SUBJECT: ISSUANCE OF AMENDMENT (TAC NO. 69543)

The amendment revises the Indian Point Unit 2 Technical Specifications to allow a fuel design transition to Westinghouse 15x15 Optimized Fuel Assemblies fuel.

INDIAN POINT NUCLEAR GENERATING UNIT NO. 2

Amendment No. 140
License No. DPR-26

FIGURE 2.1-1
REACTOR CORE SAFETY LIMIT - FOUR LOOPS IN OPERATION

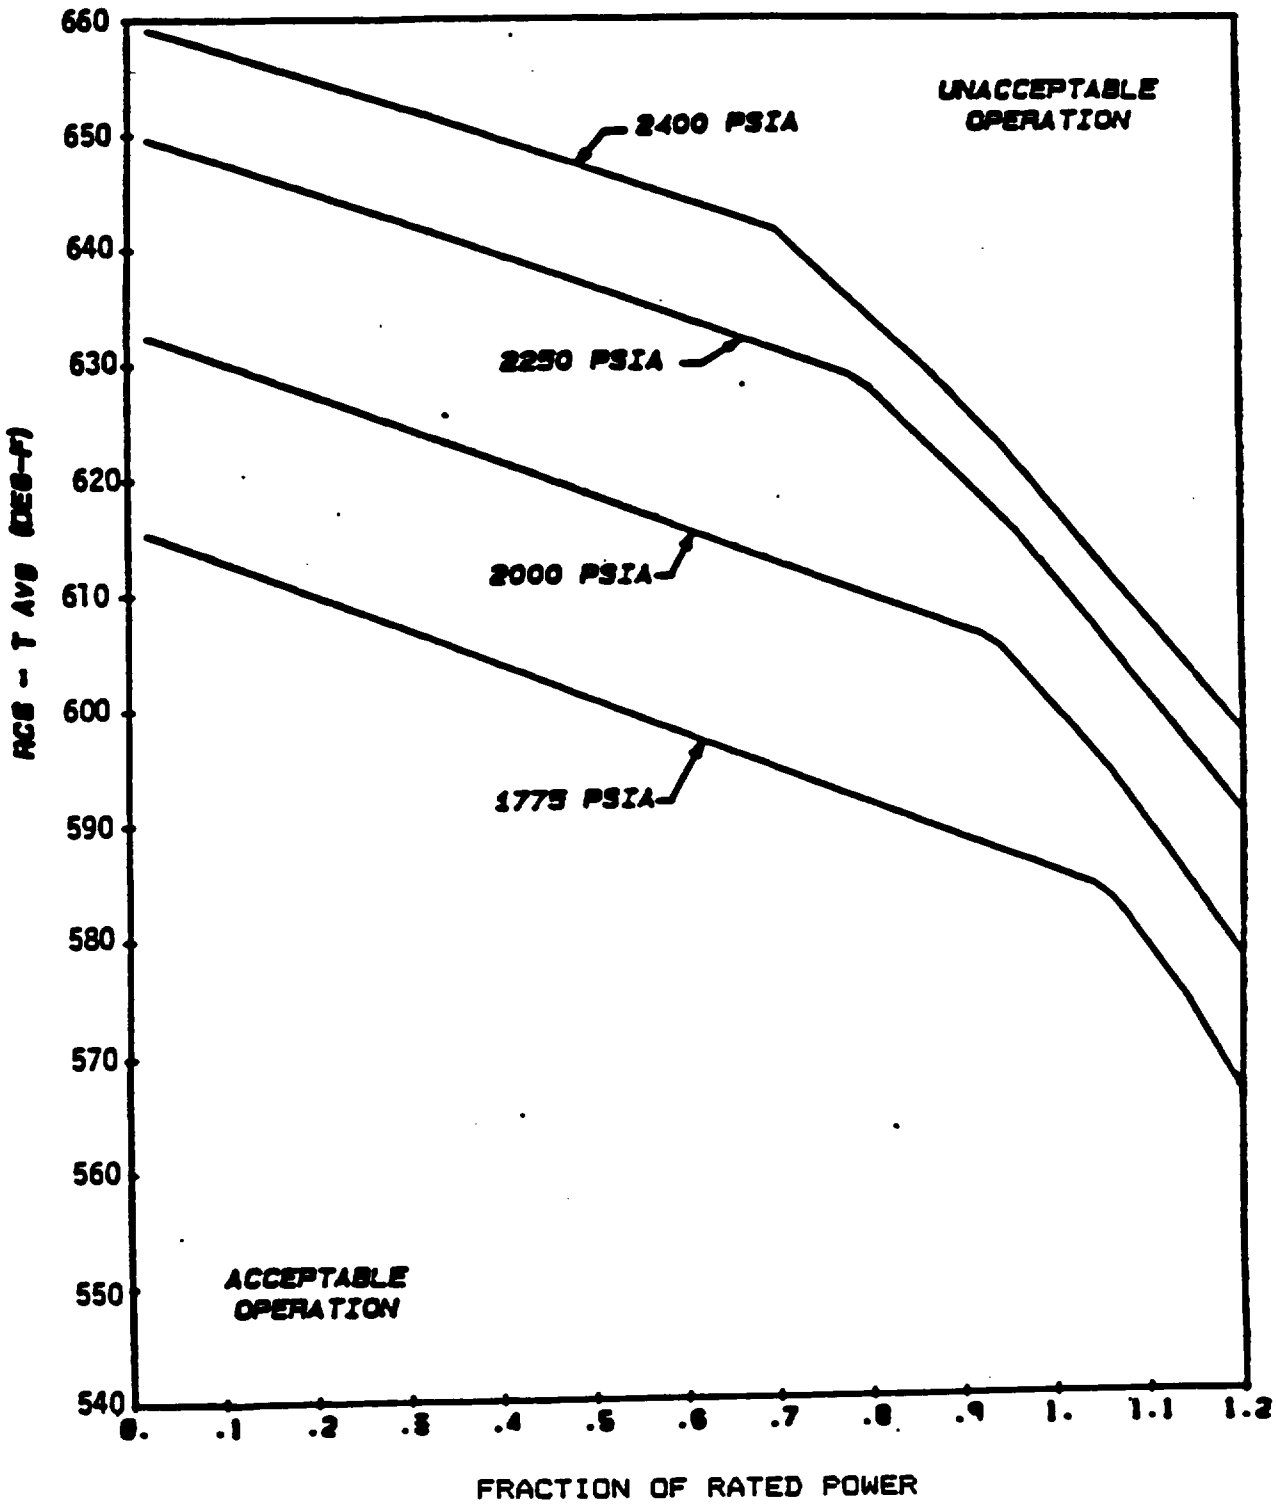
The proposed revision to Figure 2.1-1 reflects new safety limits that are based on the use of ITDP. Figure 2.1-2 has been deleted since three loop operation is not applicable at Indian Point Unit 2. We find these proposed changes acceptable.

The curves of Figure 2.1-1 show the loci of points of THERMAL POWER Reactor Coolant System pressure and average temperature below which the calculated DNBR is no less than the Safety Limit DNBR value or the average enthalpy at the vessel exit is less than the enthalpy of saturated liquid. These curves are based on a peak nuclear hot channel factor of 1.62 for the LOPAR fuel and a 1.65 for the OFA and a 1.55 cosine axial power shape.

FIGURE 3.10-2
HOT CHANNEL FACTOR NORMALIZED OPERATING ENVELOPE
(For S.G. Tube Plugging Levels up to 25%)

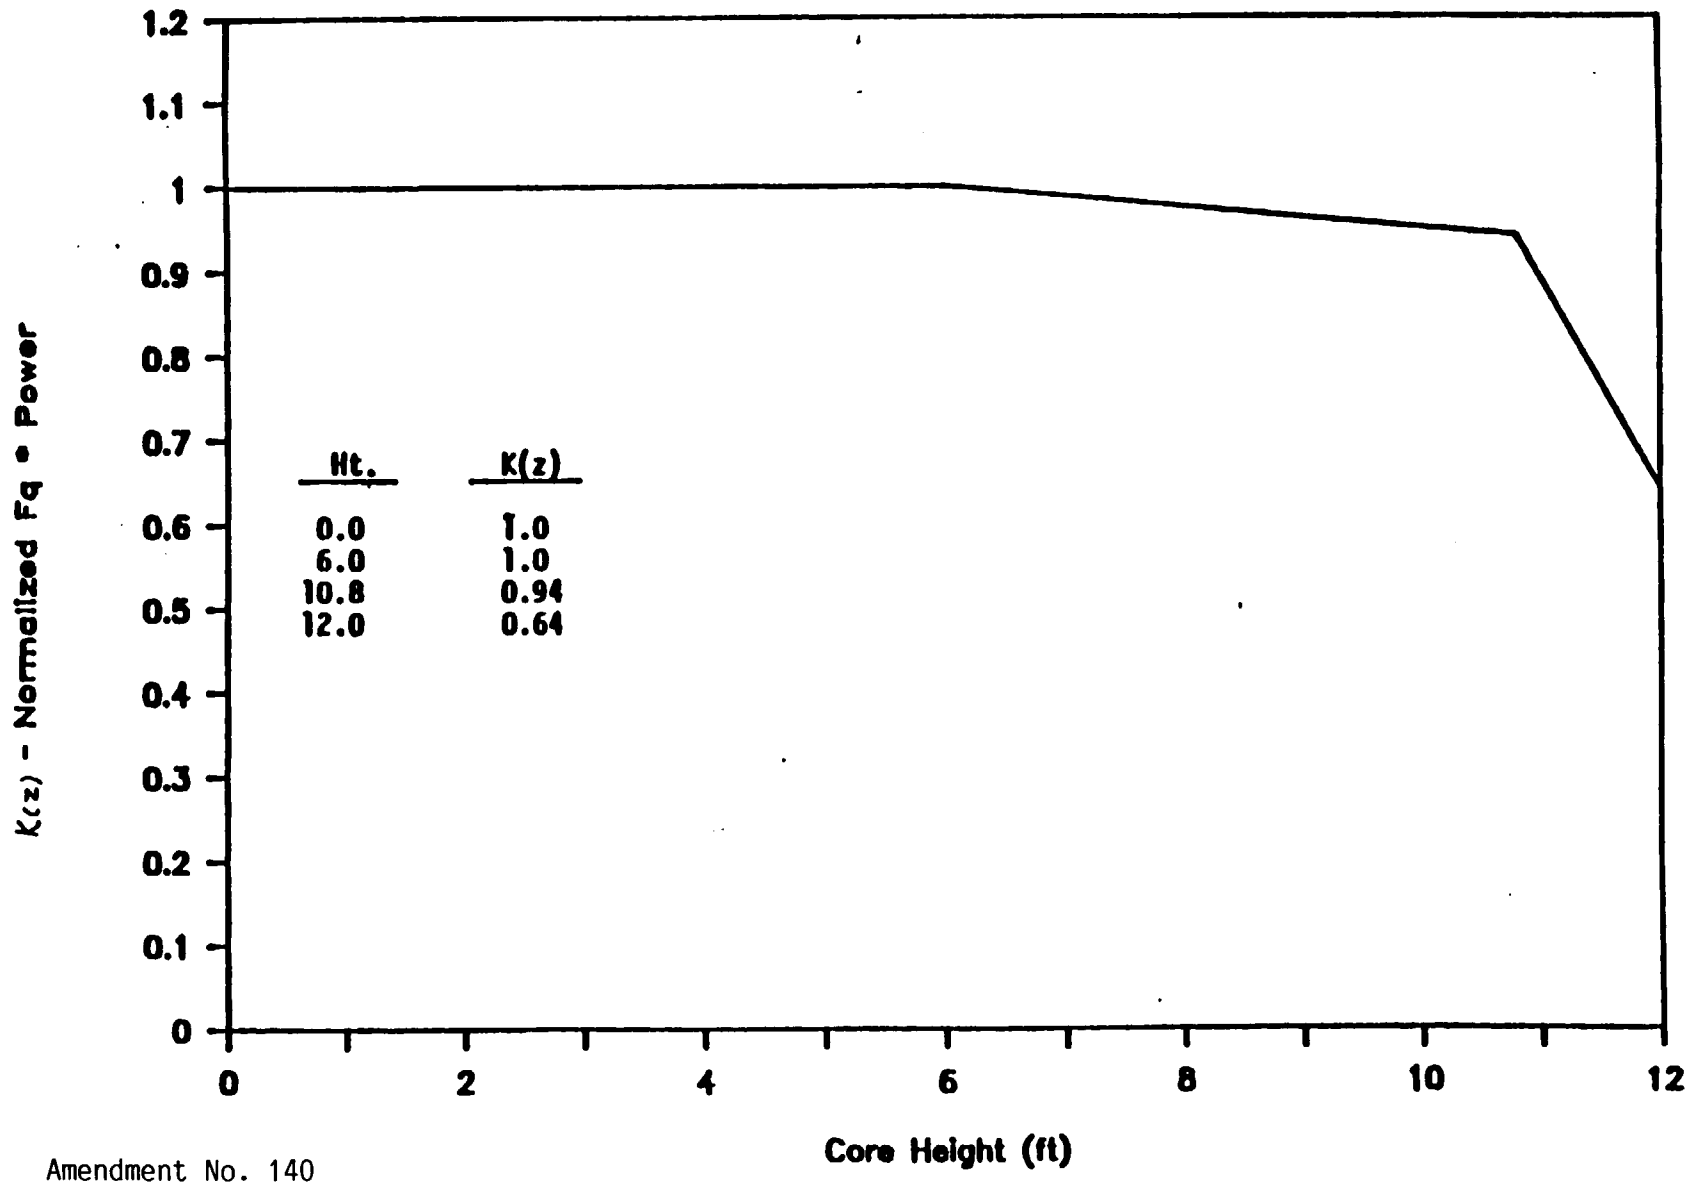
The proposed change to Technical Specification Figure 3.10-2 revises the normalized total peaking factor as a function of core height. Worst case large and small break LOCAs were reanalyzed using approved models which include more realistic axial power distributions. The results of each of these analyses demonstrated conformance with the applicable design and regulatory requirements for the axial power distribution limits proposed. We therefore find this change acceptable.
